HUMAN FACTORS EVALUATION OF THE SINCGARS ICOM RADIO

Richard L. Palmer

U.S. Army Research Institute
Fort Hood Field Unit

April 1987

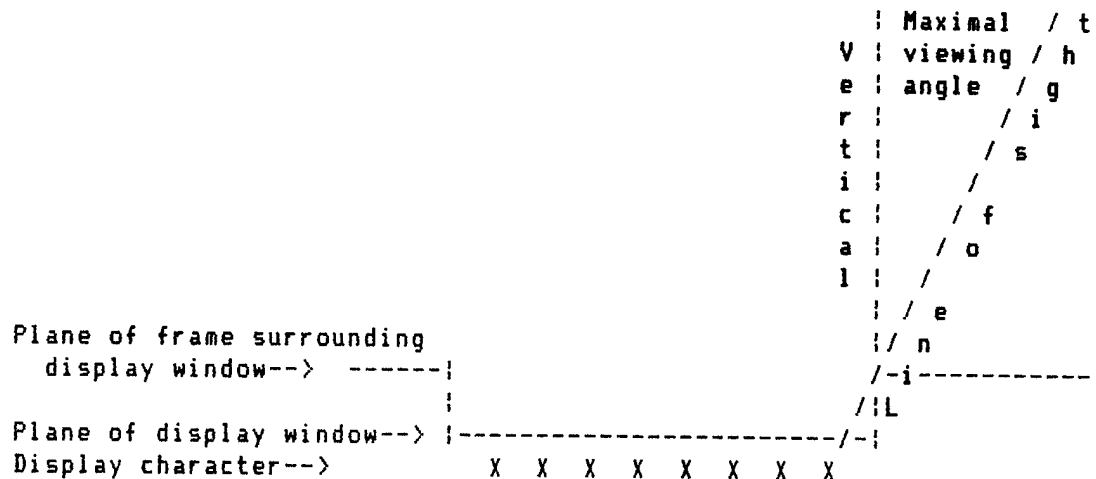
2.01 **OBSERVATION:** The maximal viewing angles for the ICOM display were measured by taking the angle between a vertical line from the plane of the display frame at the edge of the display window and a line of sight in the horizontal plane slanting away from the vertical line to the point where the edges of the characters began to be occluded from view, as in the following illustration for viewing the display from the right side:

The maximal viewing angles determined by this method were the following (they are approximate):

- 30 degrees from the top of the display
- 27 " bottom "
- 30 " right "
- 30 " left "

IMPACT: The nominal maximal viewing angles are improved over the non-ICOM radio (for which they were approximately 12 degrees above and below, 20 degrees to the left, and 25 degrees to the right). The improvement is, however, much greater than the nominal values would indicate because of the change from a five-character, seven-segment LED to an eight-character (seven used), 5 x 7 dot matrix LED. The dot matrix allows much greater detail in the display characters, thus making them considerably more distinct from one another even if the entire character is not visible because of extreme viewing angle. Furthermore, the first and eighth characters of the display (which graphically indicate signal strength and low battery condition, respectively) are not used for alphabetical or numerical messages, and the seventh character is not used at all; therefore the effective readability of the display (for alphanumeric prompts and feedback) from extreme side-viewing angles is greater than that indicated by the nominal values given. When the first, seventh, and eighth characters are not considered, the effective angles for viewing from the left and right are approximately 62 and 82

degrees, respectively. Thus, while the top and bottom angles are still somewhat restricting, the side angles are not.

COMMENTS/POSSIBLE IMPROVEMENTS: The fact that the display characters are considerably inset from the surface of the display limits the maximal viewing angles. Design efforts should attempt to minimize this inset. The bottom viewing angle (27 degrees) could possibly be widened by tapering the top edge of the frame around the keypad. (Of course, nighttime security considerations tend to work in opposition to viewing considerations, and in some situations there may be reasons to minimize rather than maximize viewing angles.)

Figure 1. Front panel of the SINGGARS first-generation Integrated COMSEC (ICOM) radio.

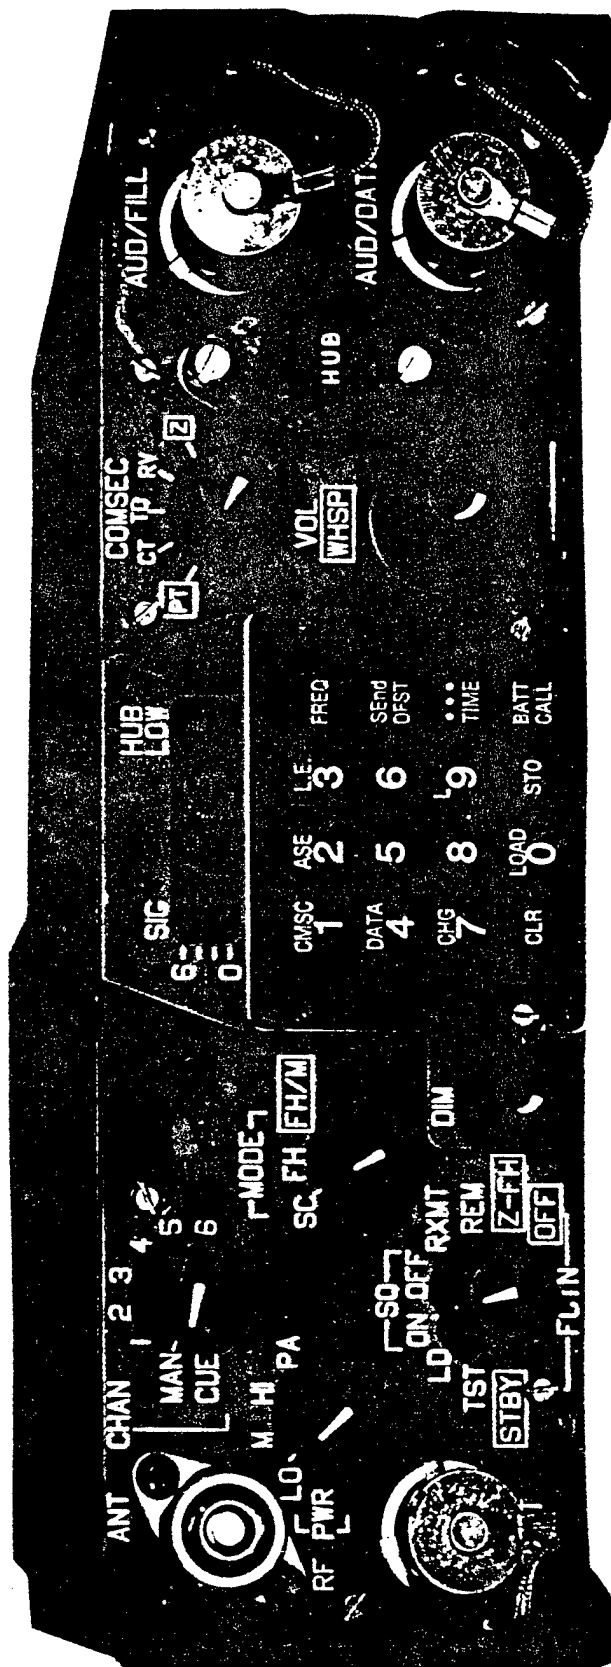
The findings are presented as observations organized into six sections: Operating Controls, Display, Labels, Connectors, Operational Procedures, and Miscellaneous. Each observation is accompanied by an impact assessment, comments, and suggested solutions. Reference may be made to Figure 1 (at the end of this document), which depicts the front panel of the SINCGARS ICOM radio.
